205142 S.S Hinge

WEBSTER UNIVERSITY ISB	
PROJECT NAME	
8274 BIG BEND BLVD	
ADDRESS	
NUMBER	
WEBSTER UNIVERSITY	
OWNER	
CANNON DESIGN	
ARCHITECT / ENGINEER	
DEVIN D GATES	
SUBMITTED BY	
123553-001 REV 2	
CONTRACTOR / CM SUBMITTAL NO.	CANNON DESIGN SUBMITTAL NO.
	123553
DRAWING / DETAIL REFERENCE	SPECIFICATION SECTION / PARAGRAPH
MANUFACTURER / SUPPLIER	ITEM / PRODUCT ID
REQUIRED DATE	PRIORITY
	CRITICAL

DATE: 1/25/2017
JOB: 04437A, B, C, D
RE: Webster University
Webster Groves, MO

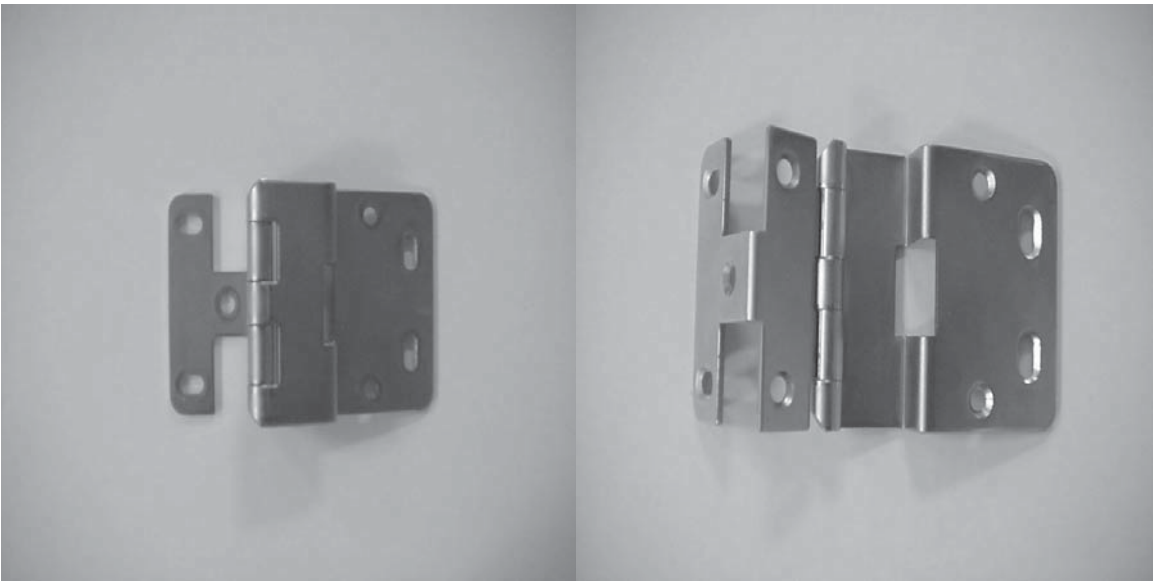
PROVIDE PER SPEC
123553, 2.12, B

PER PREVIOUS MARKUP, THIS HINGE MEETS SEFA REQUIREMENTS. IF CHANGED, IT WILL NO LONGER MEET SEFA

CLARIFY???
